Windsor Bridge replacement

Urban Design and Landscape Plan

Submissions report

September 2017

Example of the brick façades of the bridge abutments for Windsor Bridge

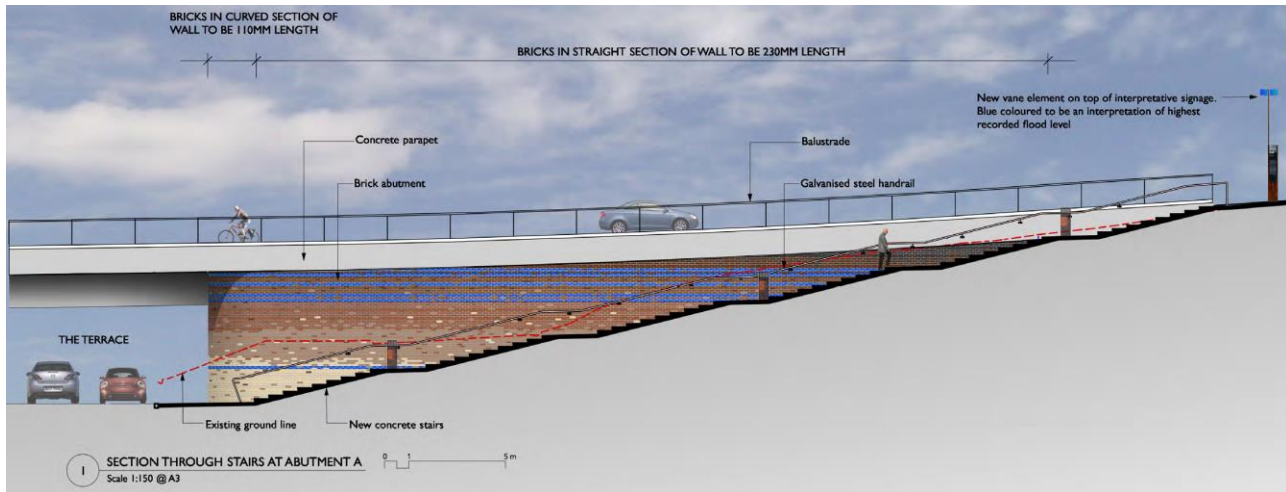
There were 10 submissions including those made by government agencies raising concerns about the choice of brick work for the bridge abutments.

Respondents stated it is unlikely modern pressed Bowral Bricks would blend in with the historic brick fabric of the surrounding area and this proposal may produce an imitation, which is not in accordance with the aims of best practice guidelines such as the Burra Charter.

Submissions also included requests to use sandstone instead of bricks to tie in with the surrounding historic buildings and gutters.

The selection of brick as the cladding material on the abutments considers the scale of the abutment, durability, maintenance, material lifecycle costing and context.

The bridge abutments will be subject to flood inundation and have rounded corners to reduce damage from flood debris. The proposed brick façades will be robust to withstand flood damage.

Since receiving submissions, the brick façades of the bridge abutments have been amended to make them more decorative to ensure it is not seen as mimicking the surrounding heritage buildings and structures. (See appendix E)

Example of lighting option for Windsor Bridge

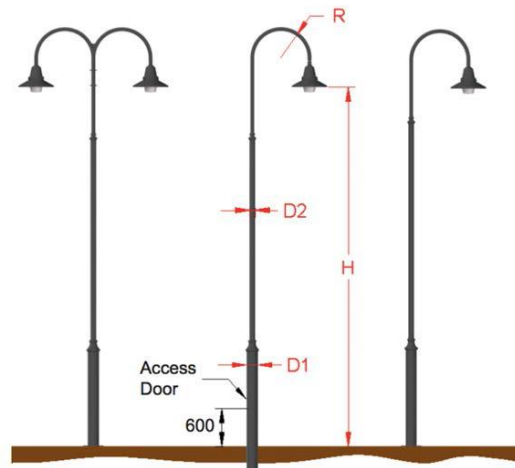
Community and government agency submissions questioned the choice and location of street lights within the project area, with some commenting it may be out of context or character.

- positioning the lights away from Thompson Square to not affect the appearance of the new shared path
- 'light pollution' should be reduced as much as possible to assist in maintaining perception of minimal lighting in the area

- lighting to tie in with historical surroundings
- lighting to be in line with Endeavour Energy's list of acceptable lights for maintenance purposes.

The lighting has been designed to meet Australian Standards and the location of the lights provides the required illumination.

Roads and Maritime has further consulted with Council and the Office of Environment and Heritage about lighting in Thompson Square parkland to select appropriate lights which have a heritage style. A sample is shown in Appendix F. These lights are being included in the updated Plan, which will be available on the project web page once completed.

The proposed bridge and road lights have been designed to collapse during a flood event. In order to facilitate timely repair and /or replacement after a flood, standard light poles and lights have been chosen from an Endeavour Energy standard list of approved lights. The proposed lights are a balance between meeting the asset owners and manager's requirements and respecting the unique heritage values of the area.

Example of flood interpretation levels on the new bridge abutment

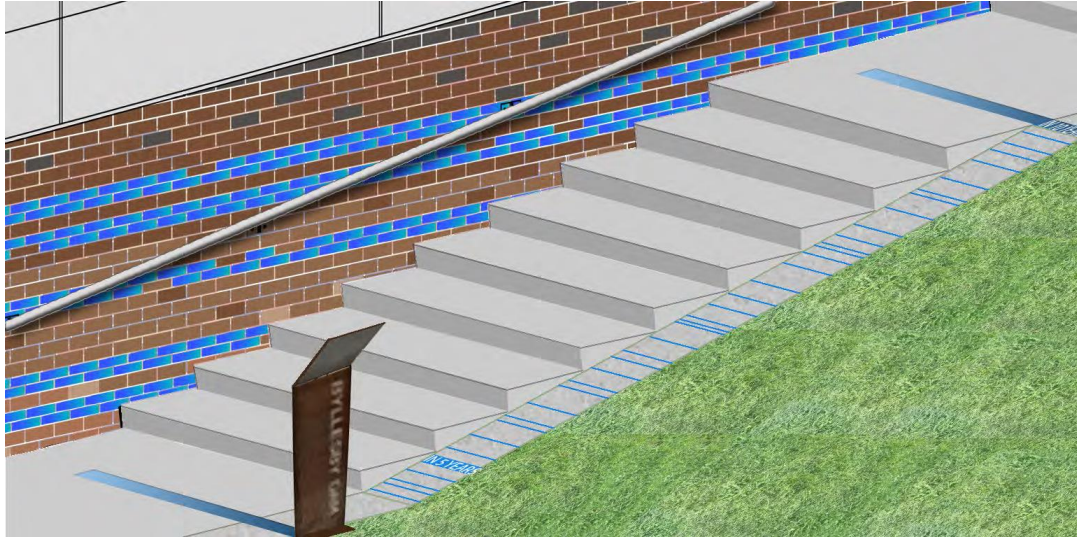
The proposed interpretation of using horizontal lines of blue bricks to represent flood levels has been said by one respondent to be overly simplistic. It was suggested other opportunities might exist for improved and more meaningful interpretation through the use of historic images where flood levels could still be included but in a more creative and dynamic way. Possible use of murals or similar interpretative devices should also be considered. (See Appendix G)

One submission asked for flood markers to be incorporated into the abutment as brass rods inscribed with the height and year of each flood and for the markers to be installed horizontally (by height) on the northern abutment and vertically (by year) on the southern abutment.

The draft Plan states on page 37 there is the opportunity for flood interpretation information to be installed on the southern abutment and stairs in the brick patterning.

Since the exhibition and receipt of submissions, the design of the abutment and the interpretation of the flood levels have been further developed, refer 2.2.1 above. This development will be

included in the draft Plan which will be displayed on the Roads and Maritime project website once completed and approved.

Murals on the abutment were considered but were deemed unsuitable as these would be subject to flood inundation and consequential damage.
